Docket Item #1 & #2  
BAR CASE # 2016-00344 &  
2016-00345

BAR Meeting  
December 21, 2016

**ISSUE:** Permit to Demolish and Certificate of Appropriateness for a New Addition and Alterations

**LOCATION:** 703 South Lee Street

*Figure 1, Left: view of north elevation of 703 S. Lee Street, taken from South Lee Street looking westward.  
Figure 2, Right: view of north elevation of 703 S. Lee Street, taken from the south side of Franklin Street, looking southward.*

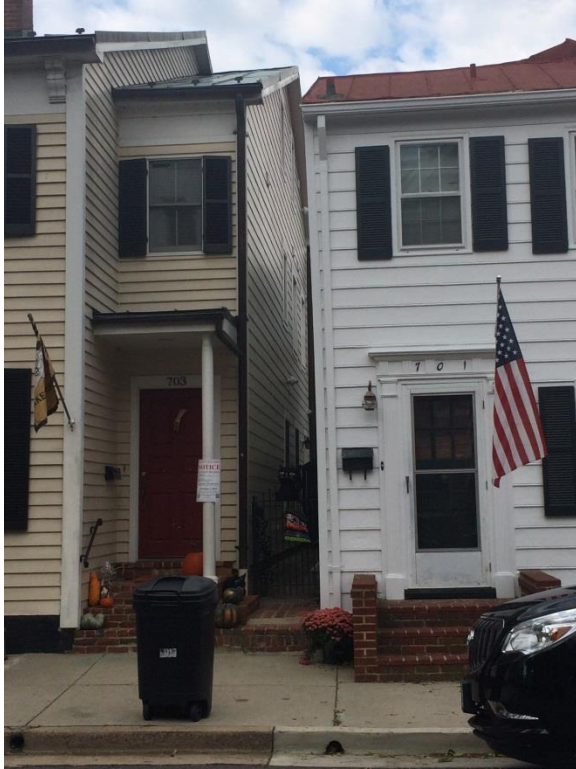
*The remainder of the proposed window revisions on the north elevation is unchanged from before and, as staff noted previously, is minimally visible looking down the horse alley from South Lee Street (see Figure #1, below). Although the intersection of the rake boards on the west elevation where the dormer meets the shed roof is a bit awkward, staff reminds the BAR that this elevation is not visible from a public way and is not subject to BAR review. This elevation is provided simply to explain the overall dormer form.*

All of the north elevation of the dwelling is visible, obliquely, from South Lee Street through the alley that separates 703 and 701, though a majority of the north elevation is clearly visible from several vantage points along Franklin Street. (Figures 1 and 2) The third floor of the proposed rear expansion, especially the proposed third-floor dormer windows on the north elevation, will be visible from Franklin Street.

*Figure 3: 703 S. Lee Street as seen from the north side of Franklin Street, looking southward.  
The red outline roughly marks visibility from the right-of-way.*

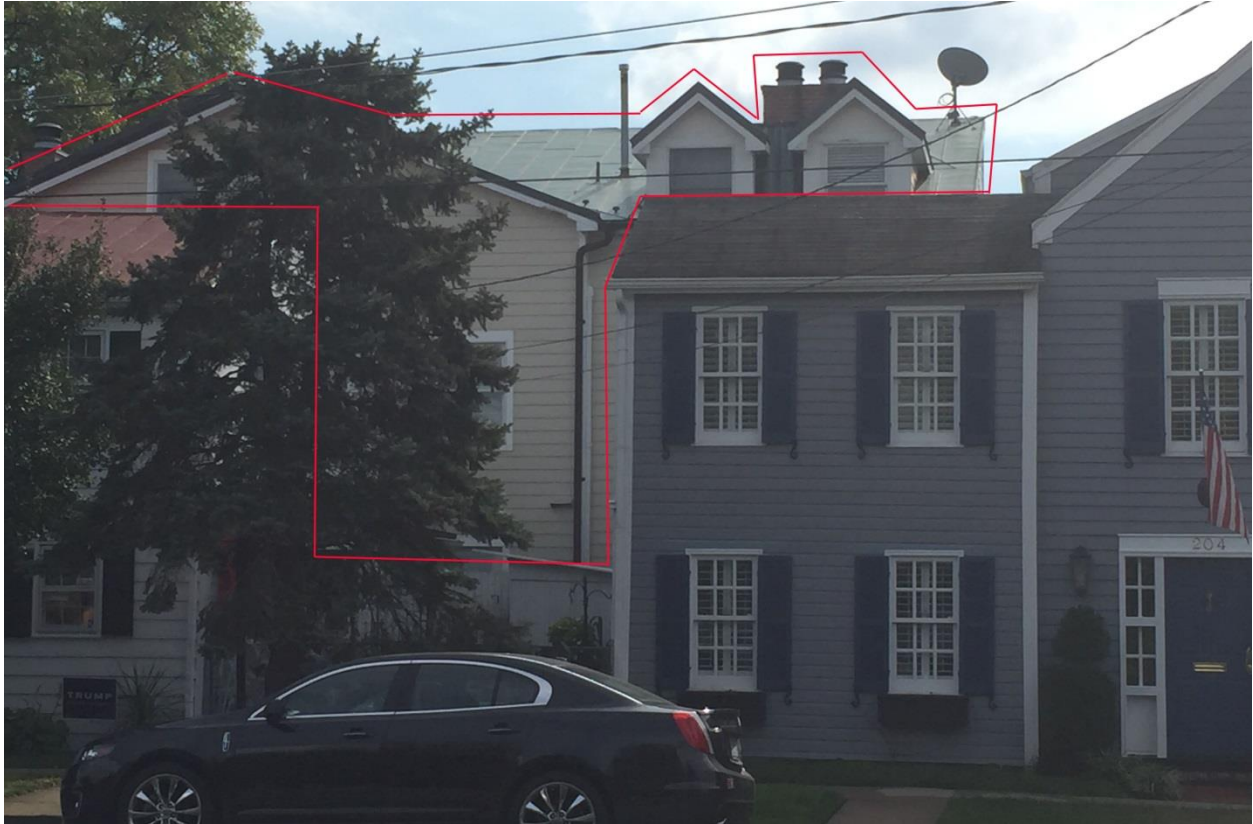
Staff is concerned that the addition of a new even larger dormer beside the two existing gable roof dormer windows on the north elevation, which are themselves already too large, would be out of scale with its context and loom over the houses to the north. (Figure 3) The proposal to have a total of three individual gable dormers—with differing fenestration patterns—in this location is also awkward, while their size and saw-tooth roof form draws undue attention to these architectural elements. The dormers are being requested to create additional habitable floor space below the steep pitch of the shed roof of the ell but they should not be overwhelming design elements and should be appropriately scaled to fit within the context of the historic buildings of merit nearby. Staff recommends deferral to restudy both the existing and the proposed dormers, perhaps considering two smaller shed dormers or a single continuous shed dormer there instead, and that the ceiling height within the dormer be limited to the top of the existing windows on the north side of the room (approximately 6'8" tall?) to minimize the height and mass of the dormers on the exterior.

(B) NEW SIDE NORTH ELEVATION  
1/8"=1'-0"

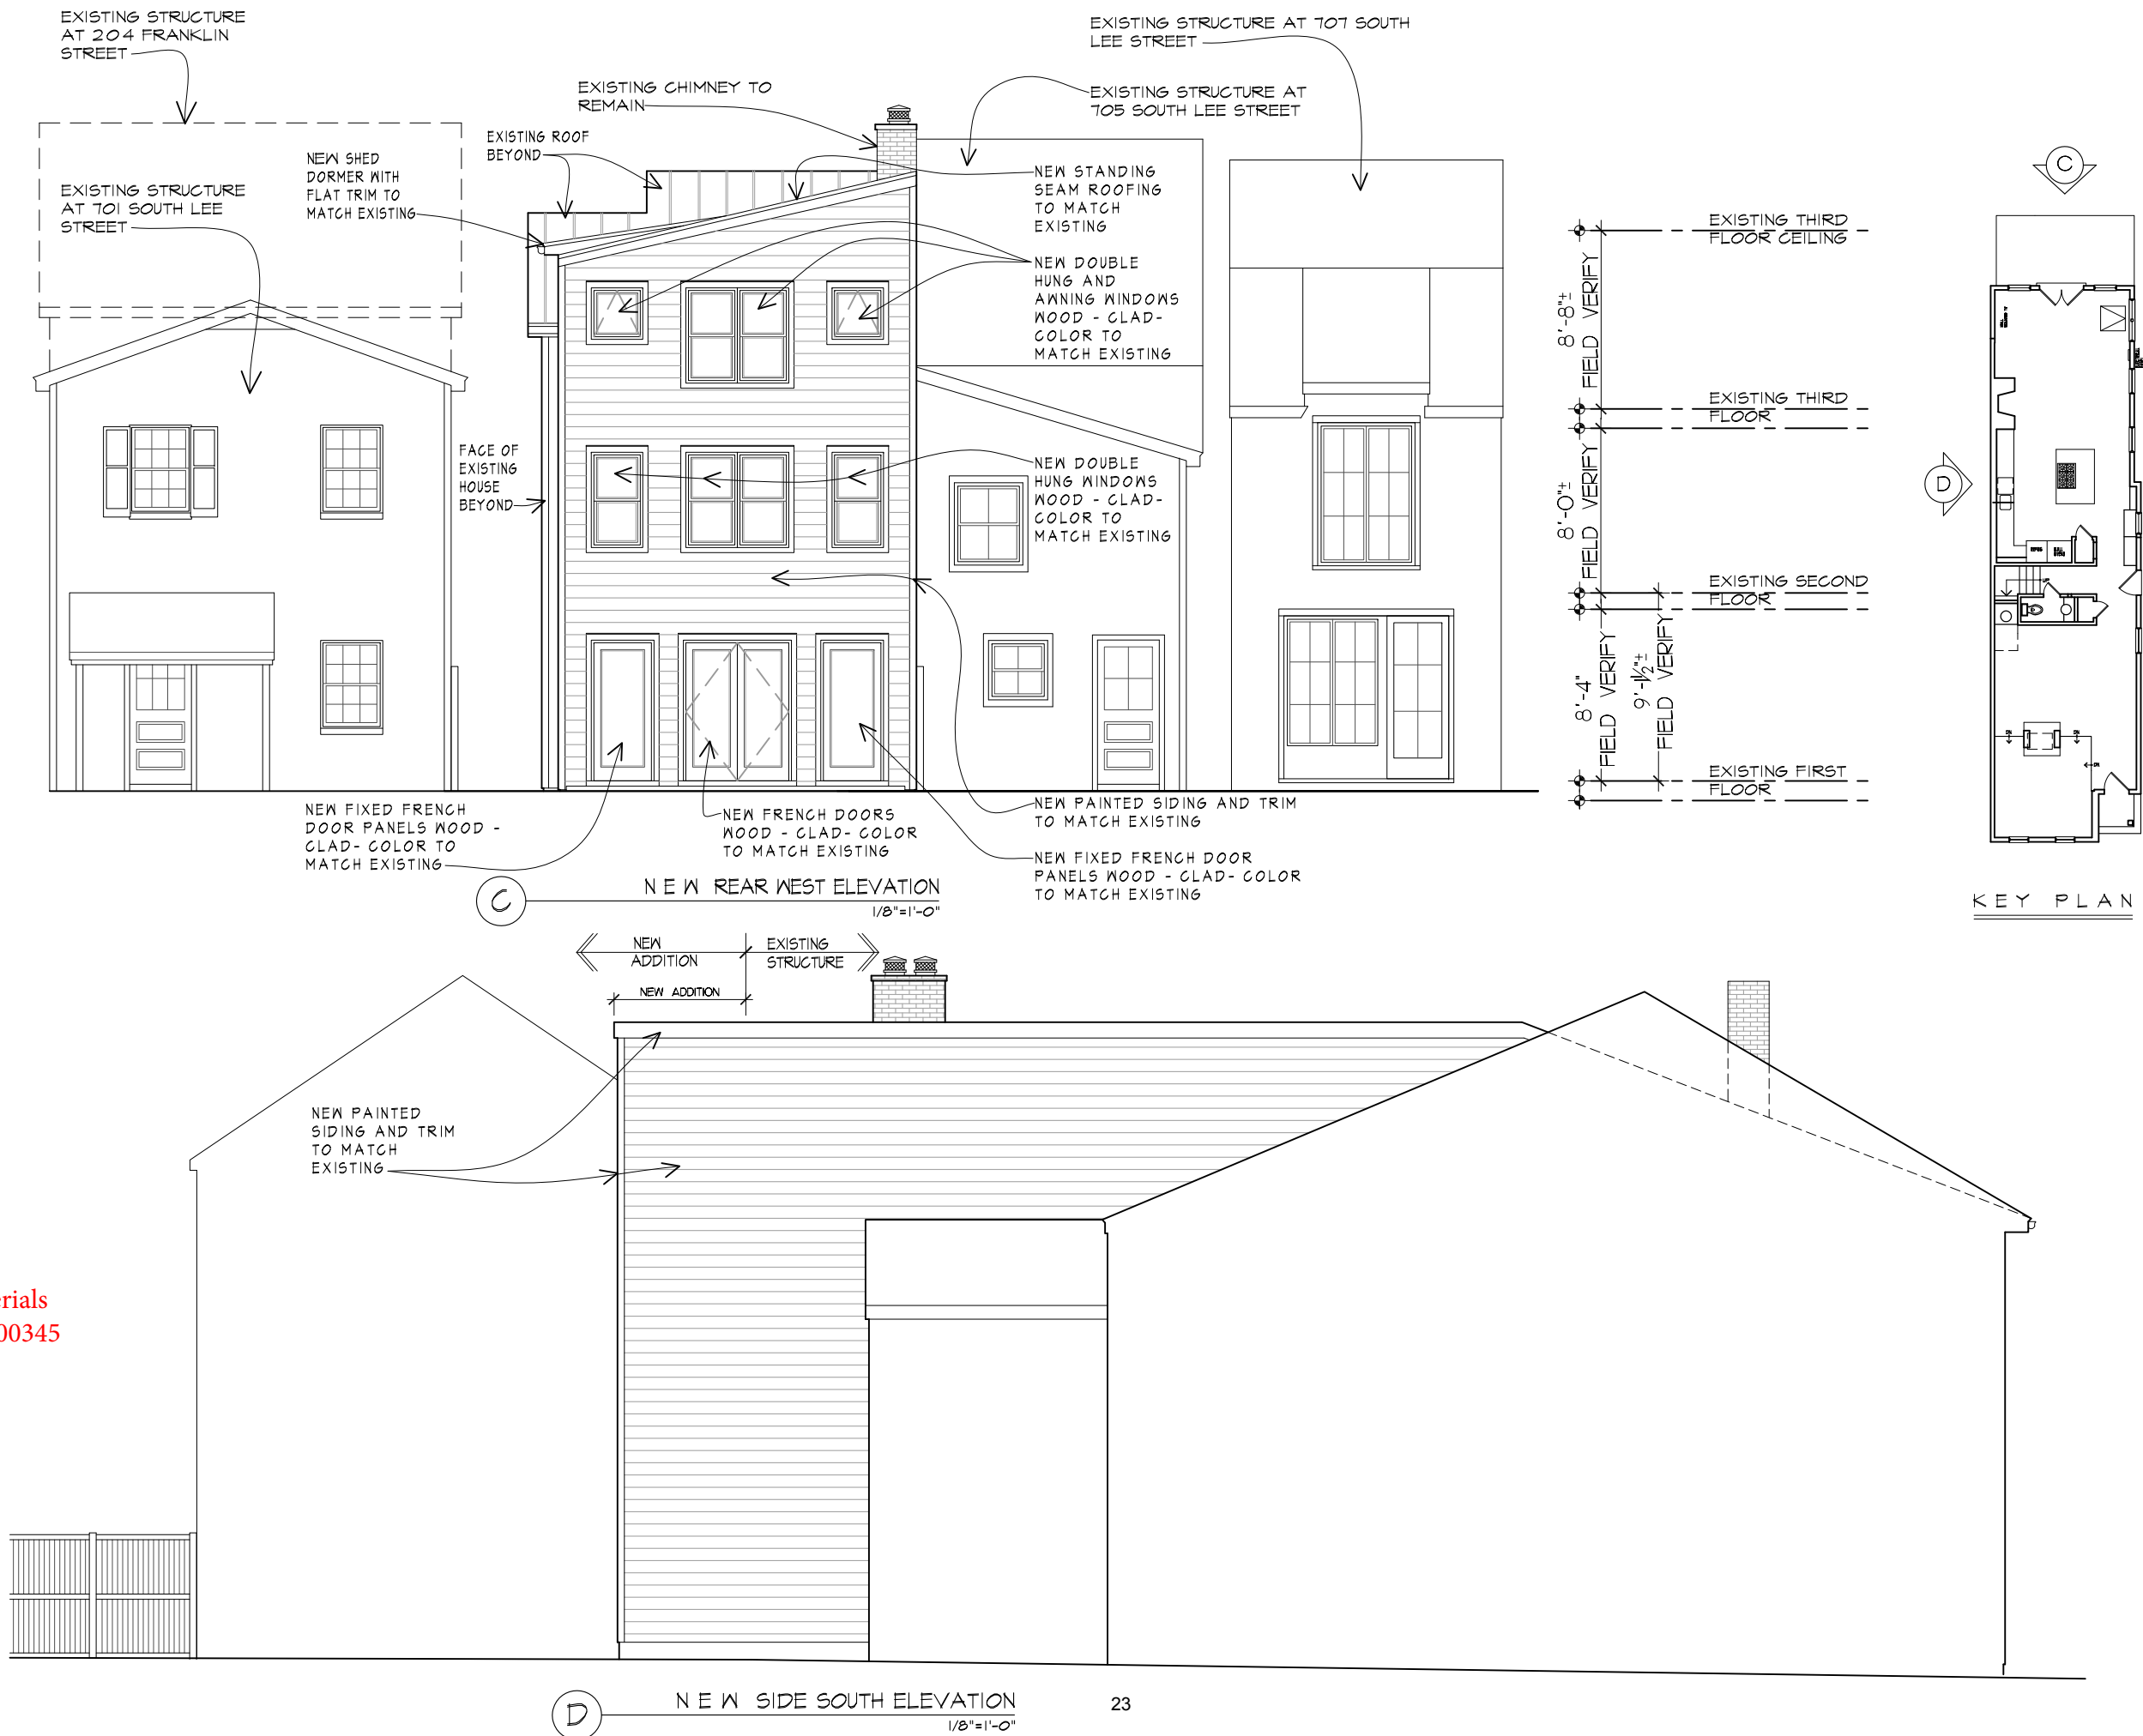
The Board found that the existing dormers and proposed new dormer on the north elevation were not architecturally compatible and suggested options for improving the fenestration. The Board described the proposed dormer pattern as A-A-B and wanted to see both A-B-A or A-A-A schemes, with conceptual support for both approaches. The Board also discussed the need for a roof plan to better understand how the addition, particularly the dormers, would integrate with the existing house and requested that a roof plan be supplied with the next submission. It was also noted that this was an opportunity to improve the window configuration from the 1993

*At the November 2, 2016 hearing the BAR noted that the roof forms shown on the proposed north and west wall elevations appeared to be in conflict and that this confusion potentially affected the dormer design. They also asked that the dormers have a better design relationship to the windows on the north wall below and that the rhythm of the dormers be more studied, so that all three have a formal composition and could appear to have been constructed at the same time.*

*The applicant has resubmitted a greatly simplified, 20<sup>th</sup>-century shed dormer form on the 1993 ell. While it is significantly wider and contains more windows than before, the front gable roofs of the previous dormers are eliminated and no longer visually project above the ridge to create a saw-tooth skyline when seen by a pedestrian from Franklin Street. From the exterior, the dormers on the rear ell are no longer trying to be a primary design feature, do not need to align with windows on the wall below or the chimney above and no longer compete for attention with the facades of other houses on Franklin Street. As can be seen on the applicant's revised context drawing on revision Sheet A-7, dated 11/28/16, the adjacent houses block the view of the majority of the north elevation of the subject house, so the proposed dormer is now a minor architectural element that visually recedes into the roof. As the Design Guidelines recommend, the proposed dormer becomes part of "contextual background buildings which allow historic structures to maintain the primary visual importance." (Residential Additions – Page 2) For the applicant, the simple, continuous shed dormer with a simpler roof form provides more interior plan flexibility, more daylight, and greater headroom.*

*Staff supports the revised dormer design and finds it is a substantial improvement over the appearance of both the existing dormers and the previous dormer proposal. The previous staff report is repeated below in its entirety for reference, with the portions no longer applicable struck thru. The revised application drawings are attached.*
